Monitoring Report MY04

**Sandy Bridge Restoration Site
DMS Contract 6400
DMS Project Number 96920**

Re: Response to Sandy Bridge Farm MY04 Report Comments

KCI has reviewed the comments prepared by the DMS for the Sandy Bridge Farm MY04 Report and has prepared the following responses:

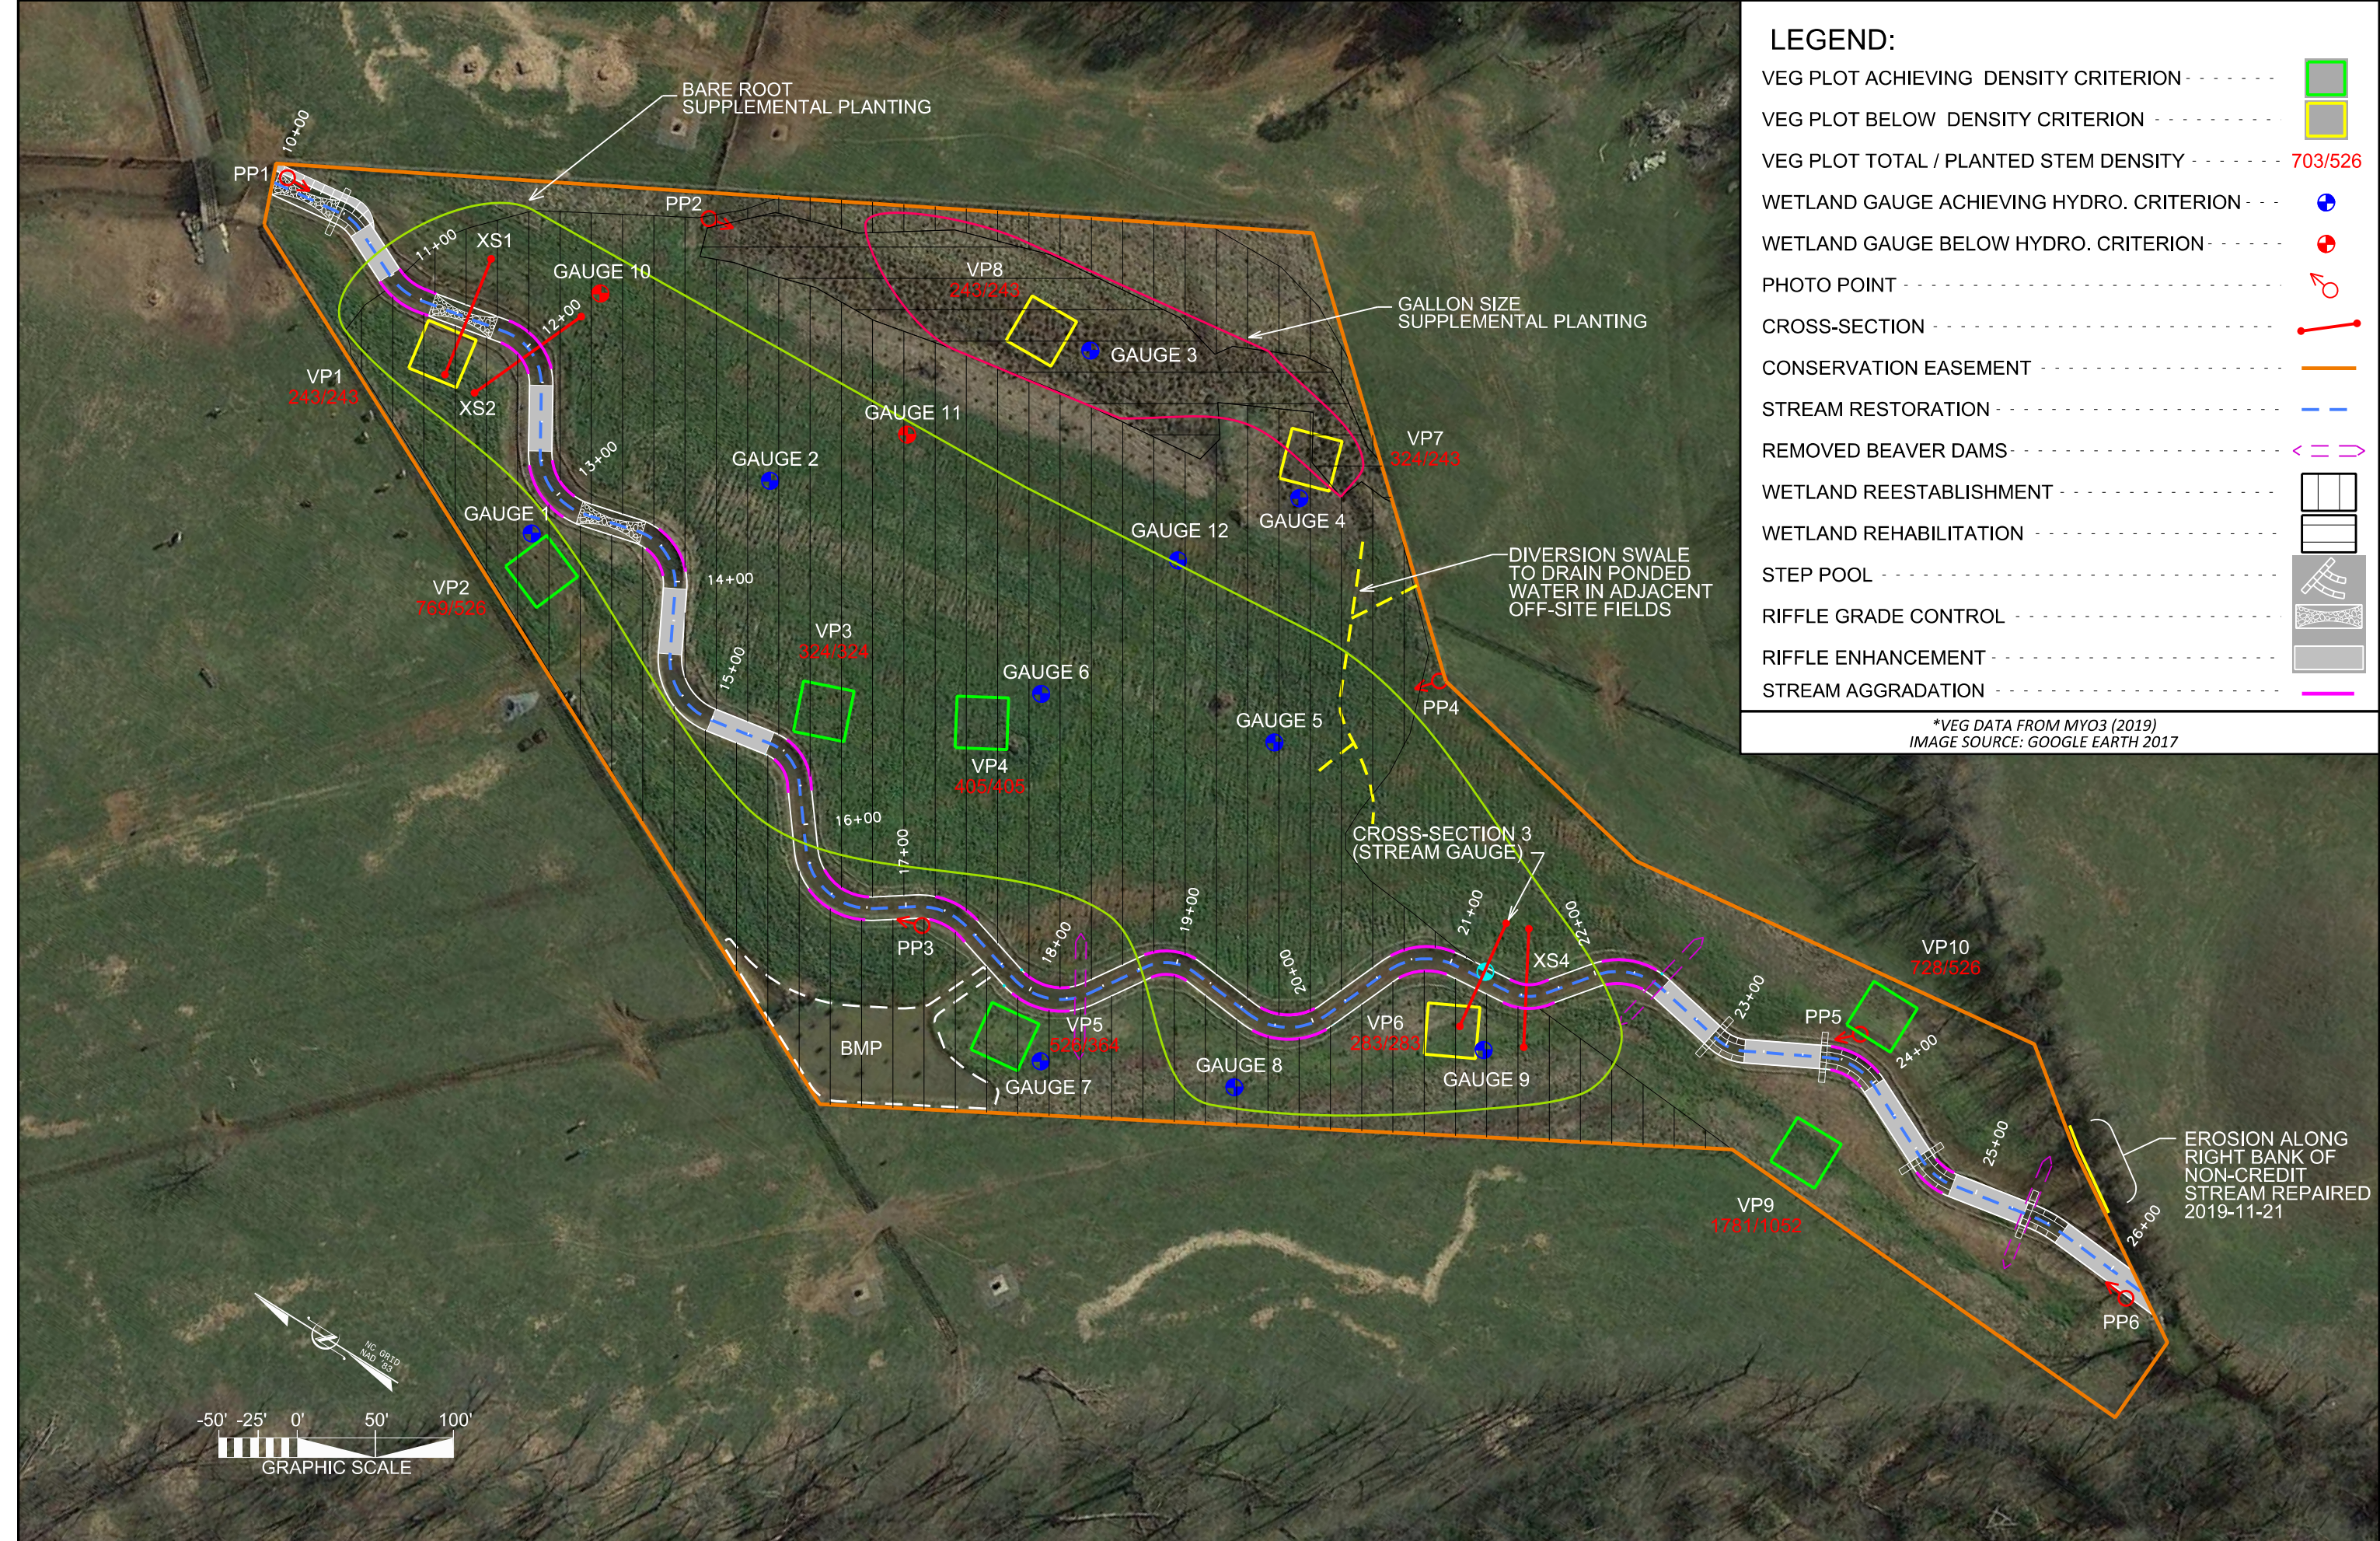
1. Aggradation (attributed to beaver) is noted in the text as a site issue however the visual assessment table indicates 100% of the project performing as intended for the aggradation metric. Both pool cross sections (XS2 and XS4) are showing the pools with significant filling in. Please field-verify and quantify/update the visual assessment tables every year as appropriate.

KCI Response: The Visual Assessment Table and the CCPV have been updated to reflect the aggradation that is present on-site as a result of the beaver impoundments.
